STATE OF FLORIDA  
DEPARTMENT OF ENVIRONMENTAL PROTECTION  
NOTICE OF FINAL PERMIT

DEP File No. 0490043-001  
Permit No.: PSD-FL-275  
Vandolah Power Project  
Hardee County

FINAL DETERMINATION  
VANDOLAH POWER PROJECT  
HARDEE COUNTY  
FOUR SIMPLE CYCLE COMBUSTION TURBINES

Figure 2 – Emissions Performance Curves for GE DLN-2.6 Combustor  
Firing Natural Gas in a Dual Fuel GE 7FA Combustion Turbine  
(Simple Cycle Intermittent Duty – If Tuned to 15 ppmvd NO<sub>x</sub>)

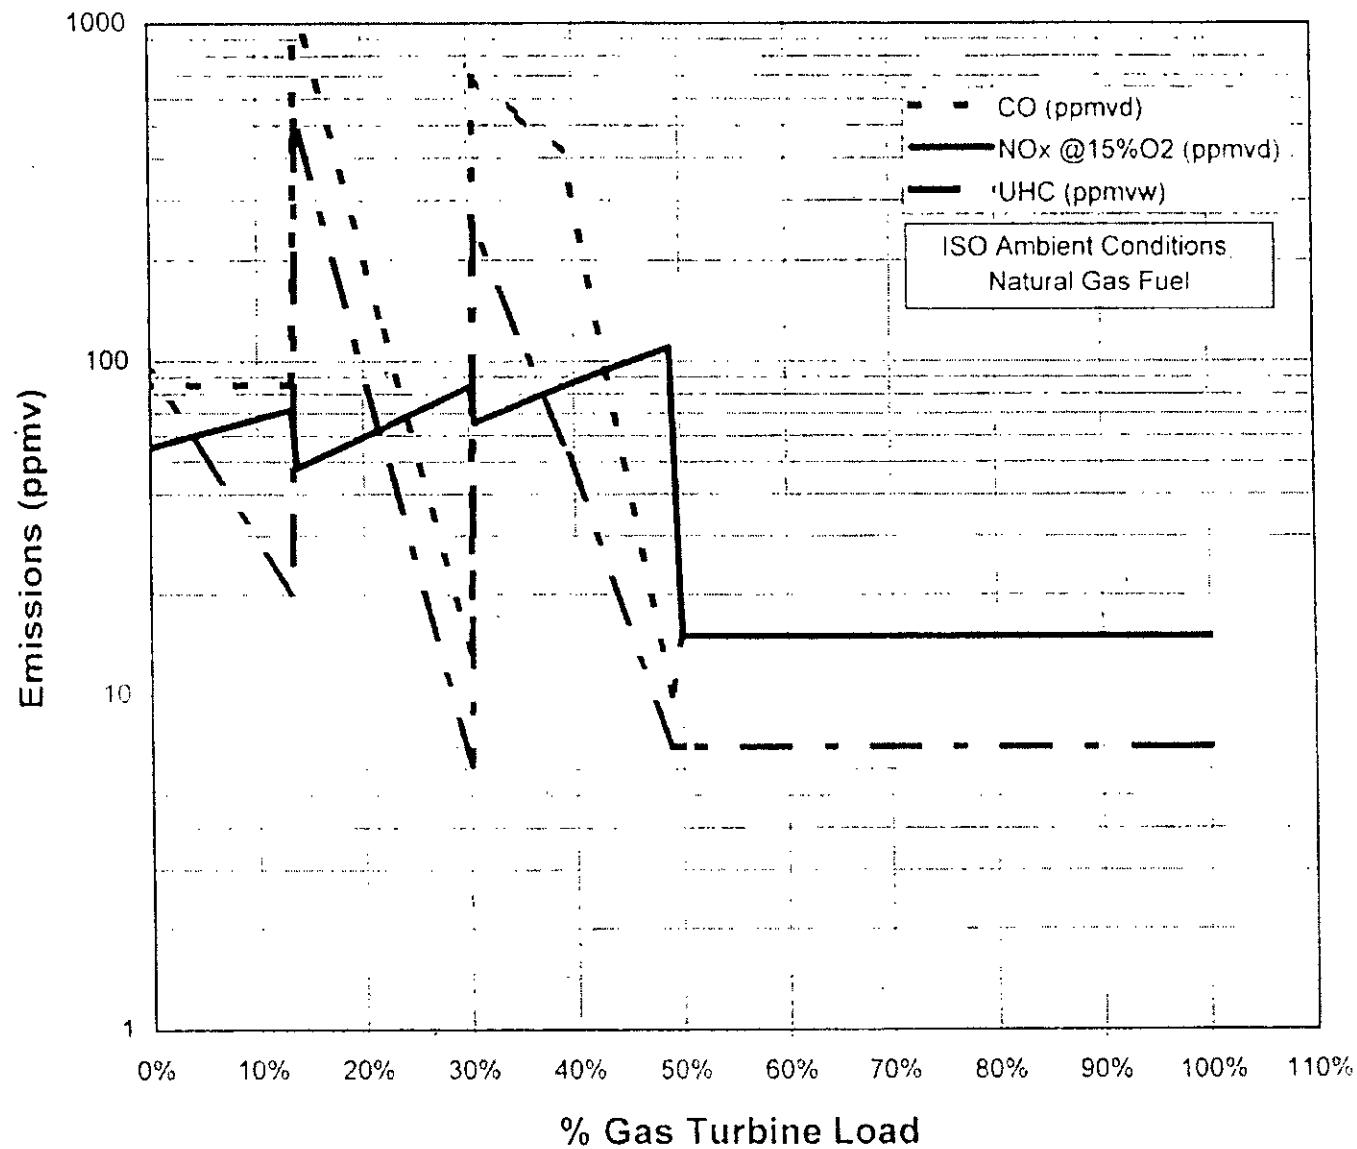
3. **(EPA)** As indicated in Conditions 25 and 26 of the draft permit, FDEP is proposing to allow excess emissions due to startup, shutdown, malfunction for up to 2 hours in any 24-hour period. It is the Environmental Protection Agency's policy that BACT applies during all normal operations and that automatic exemptions should not be granted for excess emissions. Startup and shutdown of process equipment are part of the normal operations of a source and should be accounted for in the planning, design, and implementation of operating procedures for the process and control equipment. Accordingly, it is reasonable to expect that careful and prudent planning and design will eliminate violations of emission limitations during such periods.

**(Department)** As shown in Figure 2 on the BACT, the fully pre-mixed mode for the Dry Low  $\text{NO}_x$  combustor is not attained until 50 percent of full load. In contrast to a combined cycle unit, the amount of time needed for a startup or shutdown is actually very short. Typically, the units can probably reach 50 percent of full load within 15 minutes and most likely within a half hour. Although the 9 ppmvd limit will not be achieved during these times, the unit will likely emit less than the allowable pounds per hour during the combined hours allowed for startup and shutdown.
